**Economic and Social Council**Distr.: General  
16 July 2018

**World Forum for Harmonization of Vehicle Regulations****Working Party on Automated/Autonomous and Connected Vehicles\*****First session**

**Remaining activities from the former Working Party  
on Brake and Running Gear (handover period):****Tyres****Proposal for a Supplement to UN Regulation No. 30  
(Pneumatic tyres for passenger vehicles and their trailers)****Submitted by the experts from the European Tyre and Rim Technical  
Organisation\*\***

*Insert new paragraph 3.1.15.*, to read:

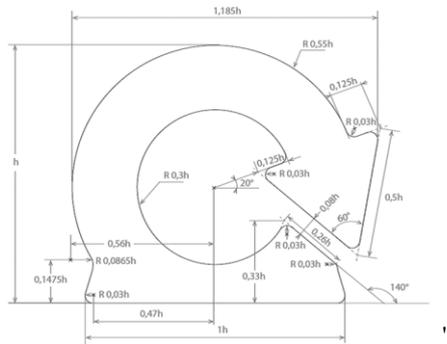
"**3.1.15. The symbol below if the tyre is an EMT, where "h" is at least 12 mm.**
